ADDENDUM NO. 5

**RE: Item #1, August 5, 2026 Letting - EM-P 0044(207)290, PCN 05X0, Charles Mix, Gregory
County - Structure (5770'-6" Steel Girder) & Approach Grading**

PLANS: Please destroy sheets E3-E7, E11, E41 & E73 and replace with the enclosed sheets, dated 7/16/26 & 7/22/26. Sheet E27A was added.

STATE OF	PROJECT	SHEET NO.	TOTAL SHEETS
S.D.	P 0044(207)290	E3	E86

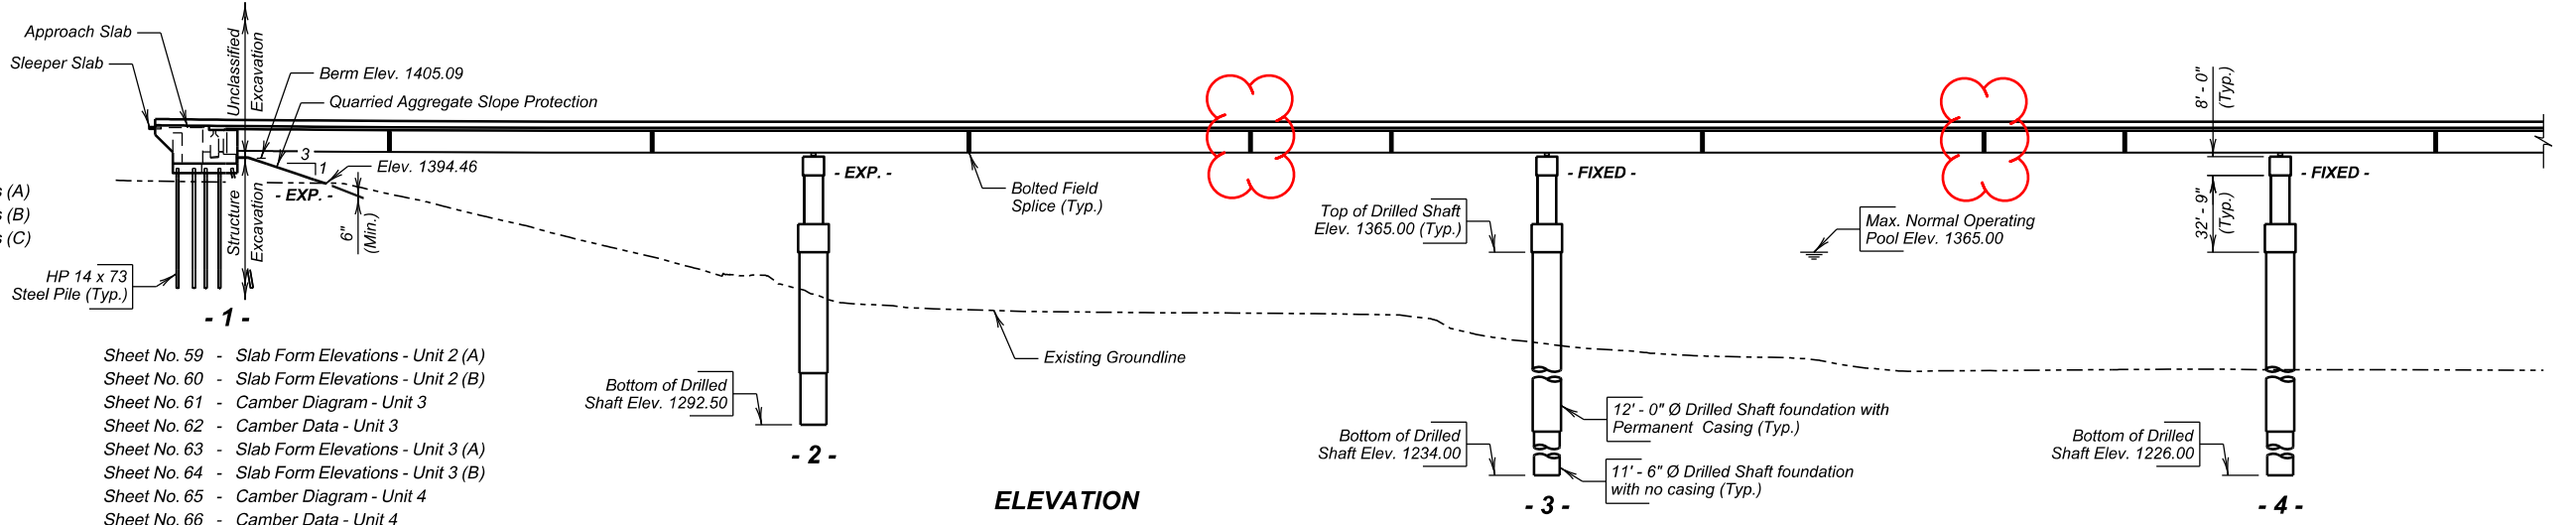
Sheets E3-E7: Elevation View was revised.

25A OF 84

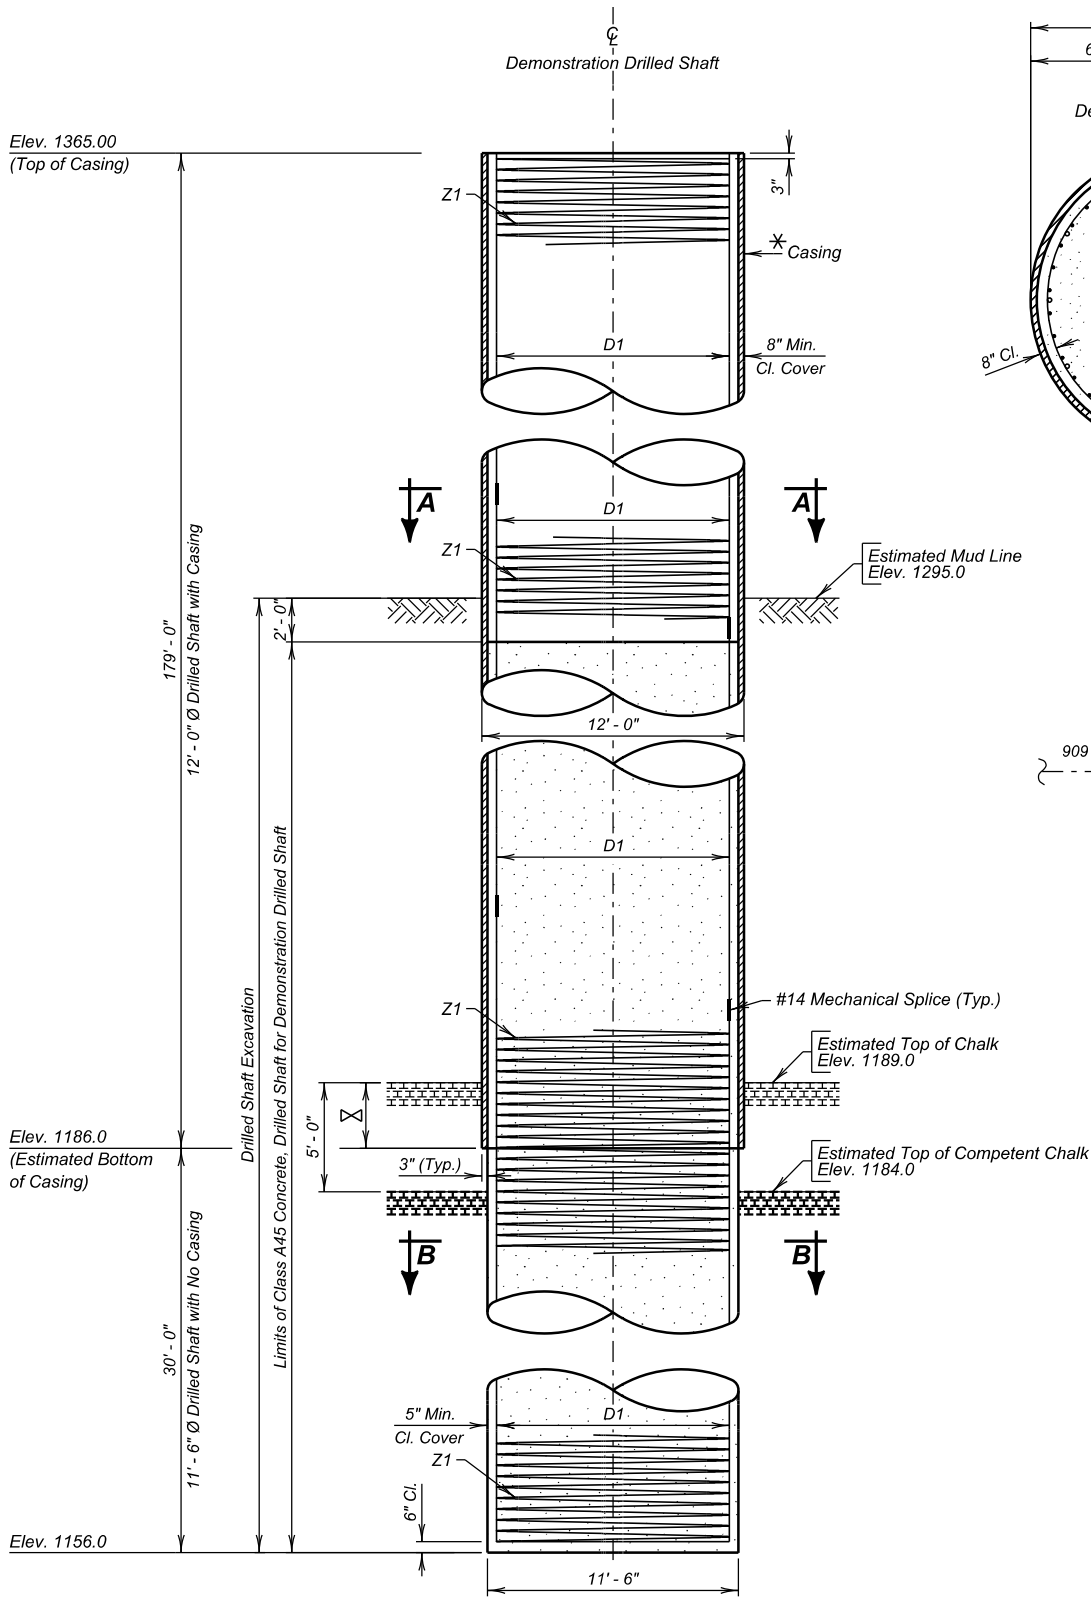
Sheet E27A: Information Only Quantity for Class A45 Concrete, Drilled Shaft were revised.

- 545.1 Cu. Yd. Class A45 Concrete, Drilled Shaft
 - 72016 Lb. Reinforcing Steel
 - 572.0 Cu. Yd. Drilled Shaft Excavation
 - 1 Each Crosshole Sonic Log (CSL) Test
 - 1 Each Thermal Integrity Profiling (TIP) Test
 - 179 Ft. 144" Casing
 - 108 Each No. 14 Rebar Splice
- Items 1 thru 7 are approximate quantities contained in the above bid items and are for information only.

STATE OF	PROJECT	SHEET NO.	TOTAL SHEETS
S.D.	P 0044(207)290	E41	E86

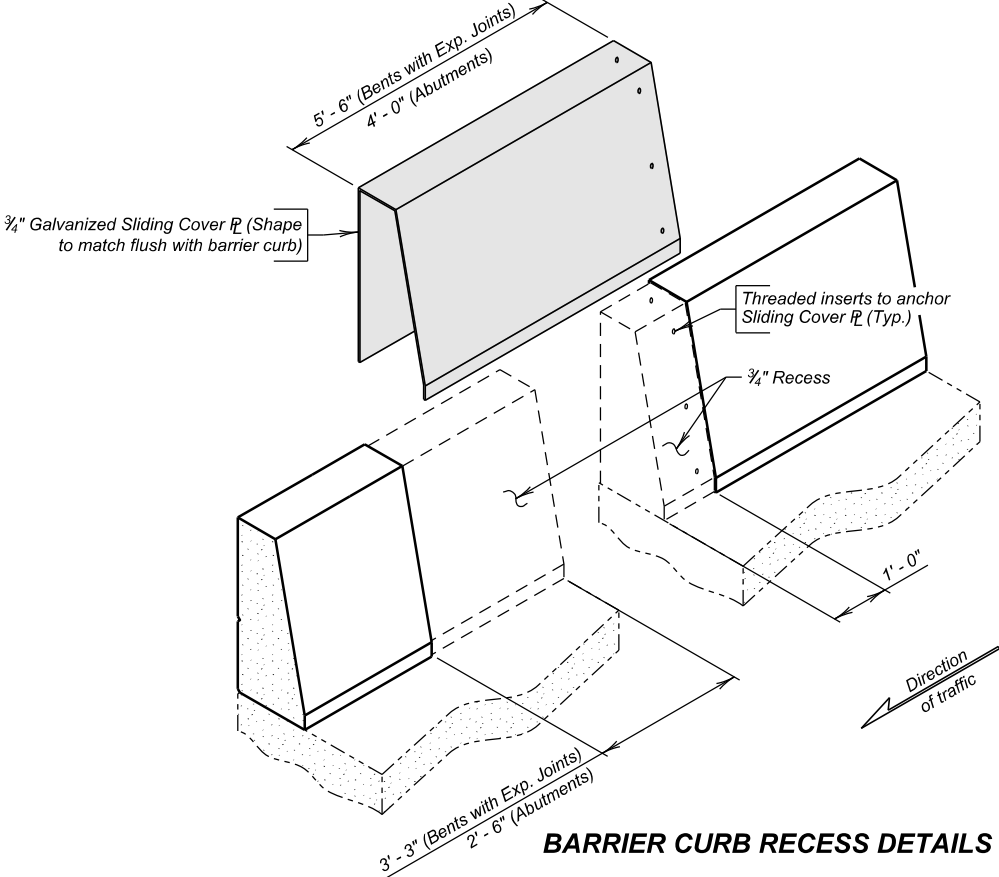
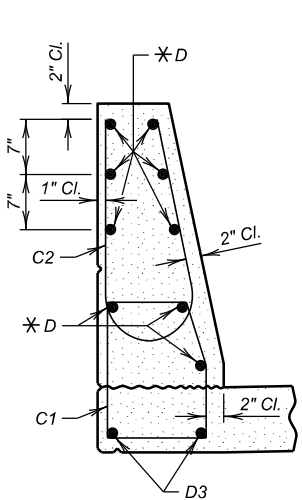
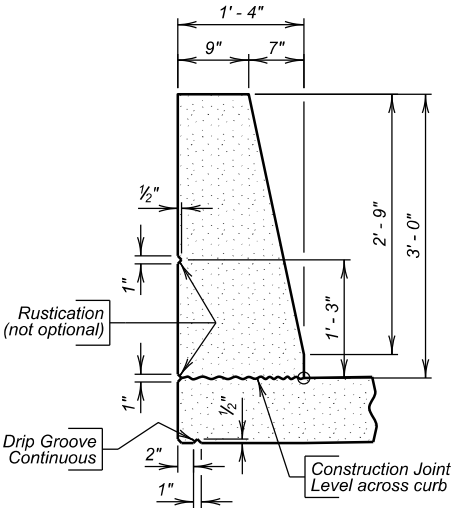
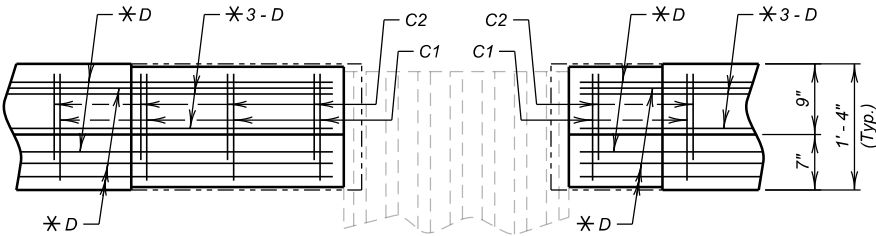
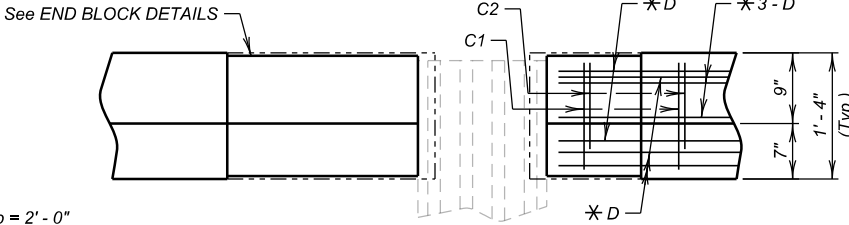
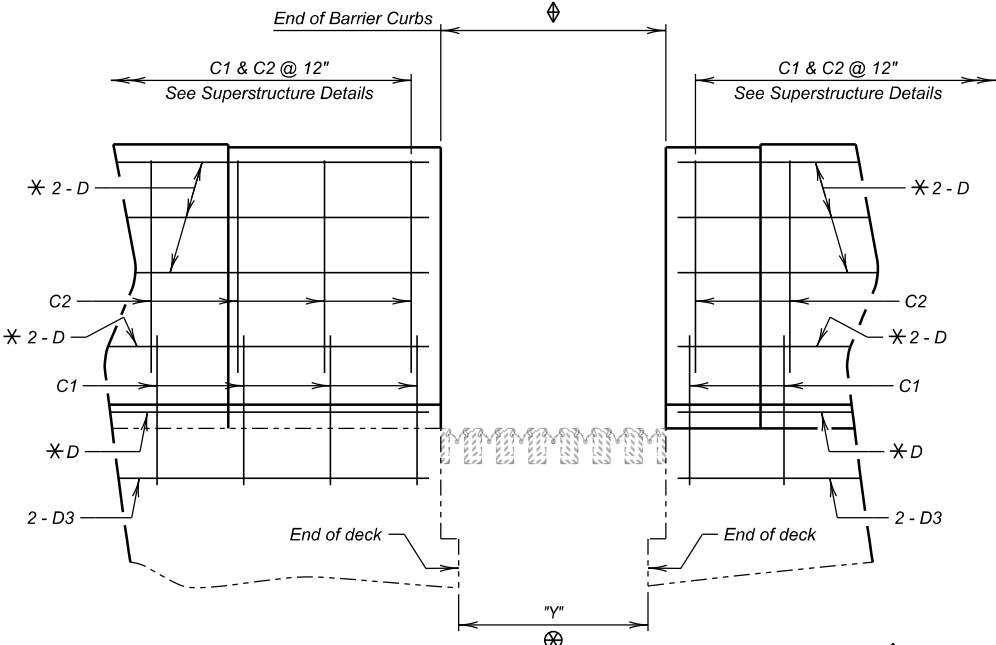
Sheet E41: SLIPFORMING METHOD OF CONSTRUCTION notes were added.

SLIPFORMING METHOD OF CONSTRUCTION:

Concrete barrier curbs may be constructed using a slipform method with approval from the Engineer provided the following requirements are met.
